HISTORIC LANDMARK COMMISSION
APPLICATION FOR A CERTIFICATE OF APPROPRIATENESS
MAY 1, 2024
HR-2024-035240
STACY HOUSE
1201 TRAVIS HEIGHTS BOULEVARD

Construct a garage apartment behind a landmarked house.

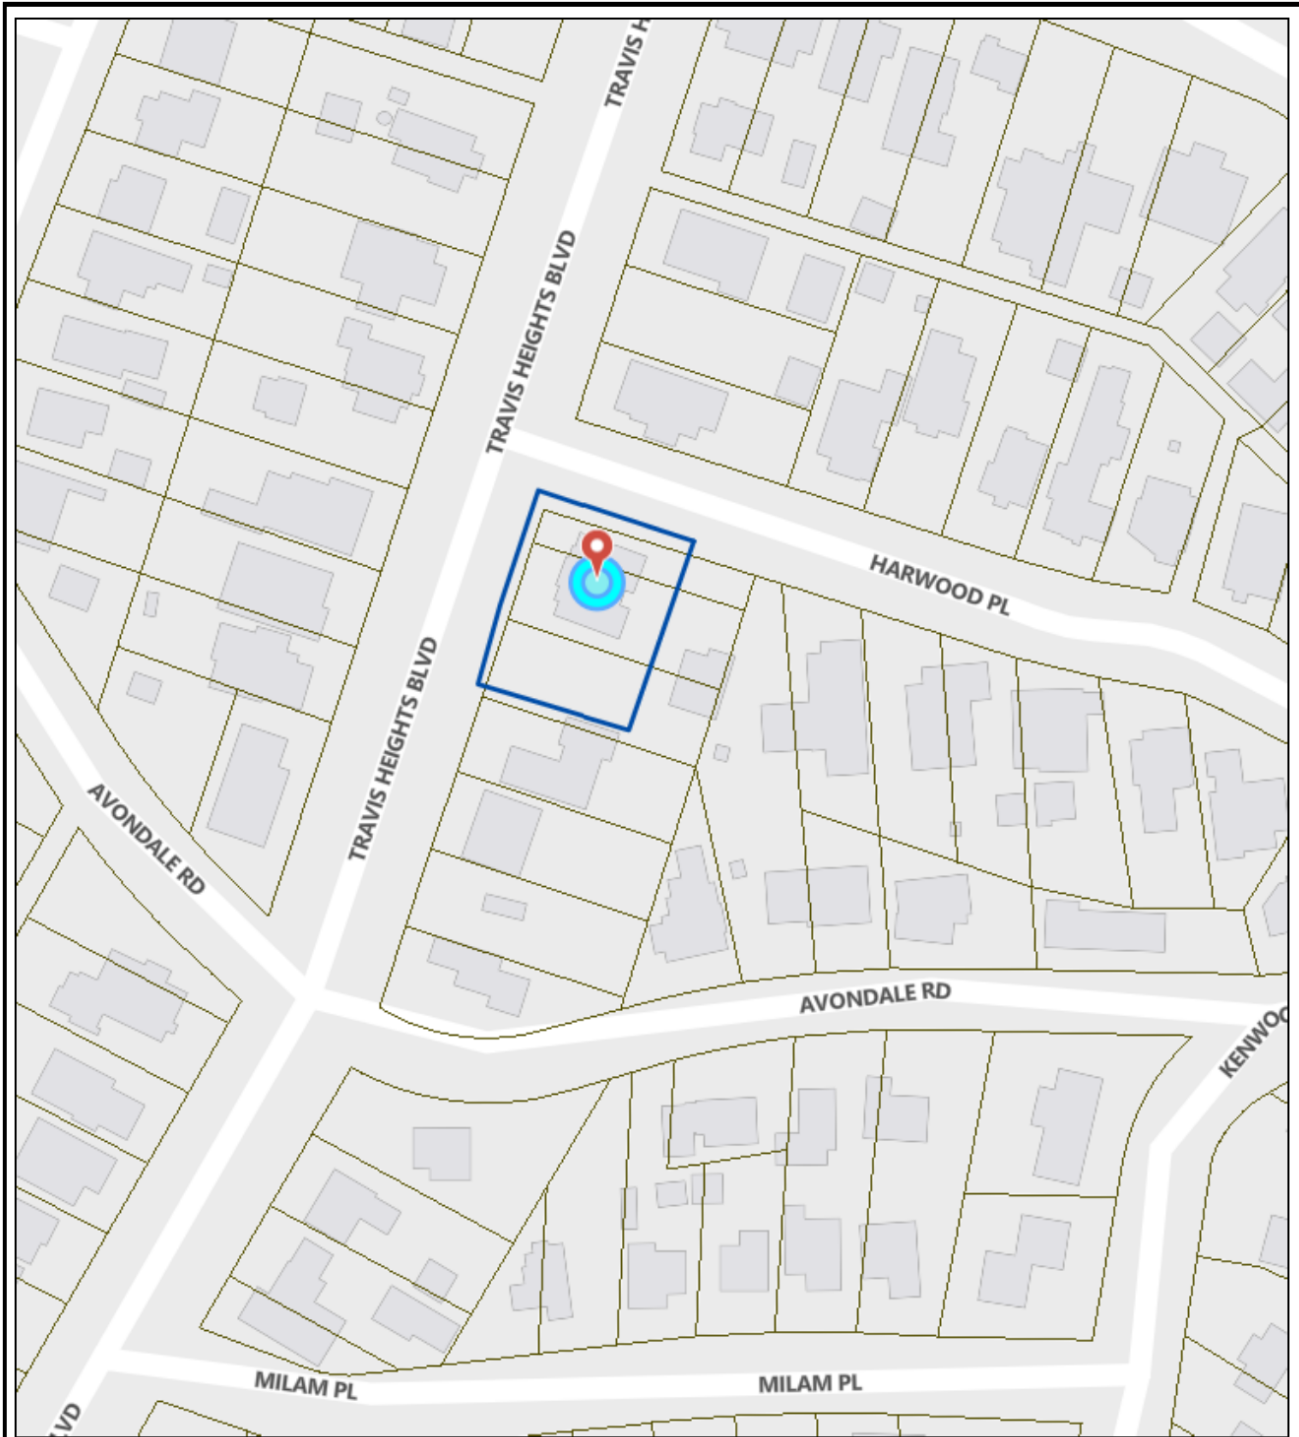
While front and rear fenestration appears appropriate, the windowless secondary elevations do not reflect the main building's style or design.

Approve the application but encourage the applicant to add windows at the secondary elevations. Alternatively, consider postponing to June 5, 2024 to invite the applicant to the next meeting of the Architectural Review Committee.
